HIROSE ELECTRIC CO., LTD.
2-6-3 Nakagawa Chuoh, Tsuzuki-ku, Yokohama, JAPAN

FH75M-100S-0.4SH(05) Shape Change and Drawing Revision

[Details of Changes] FH75M-100S-0.4SH(05)

Housing

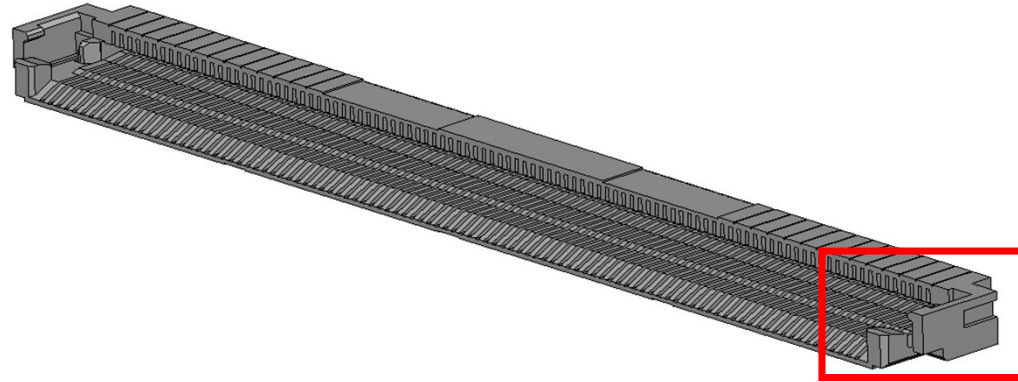
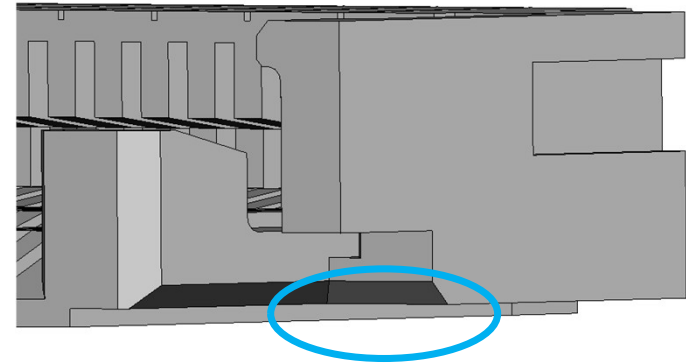
Before change: Housing without taper

After change: Housing with taper

Adds a taper to the bottom face of the housing

Actuator

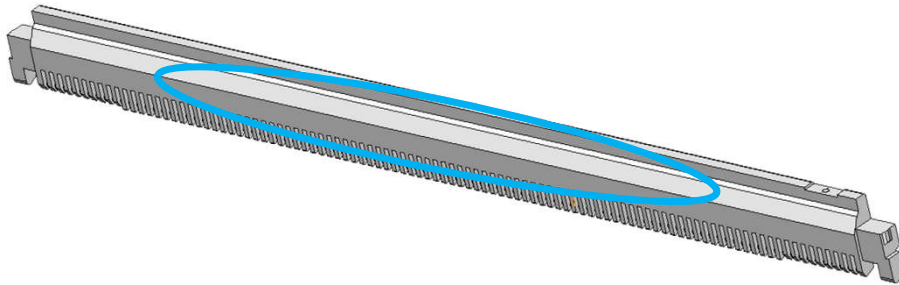
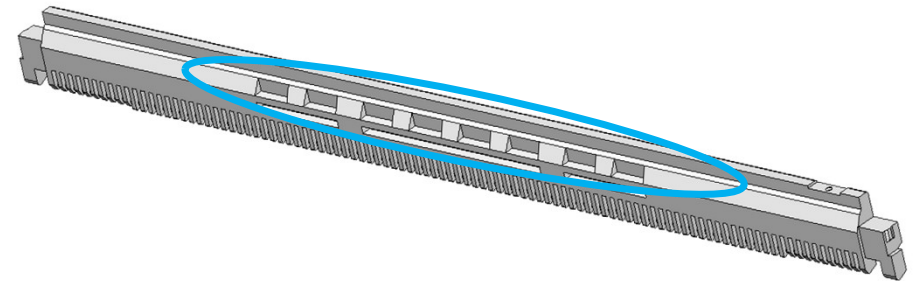
Actuator back side
Before change: No Core-out

Actuator back side
After change : With Core-Out

Design change to back side of actuator (core out)
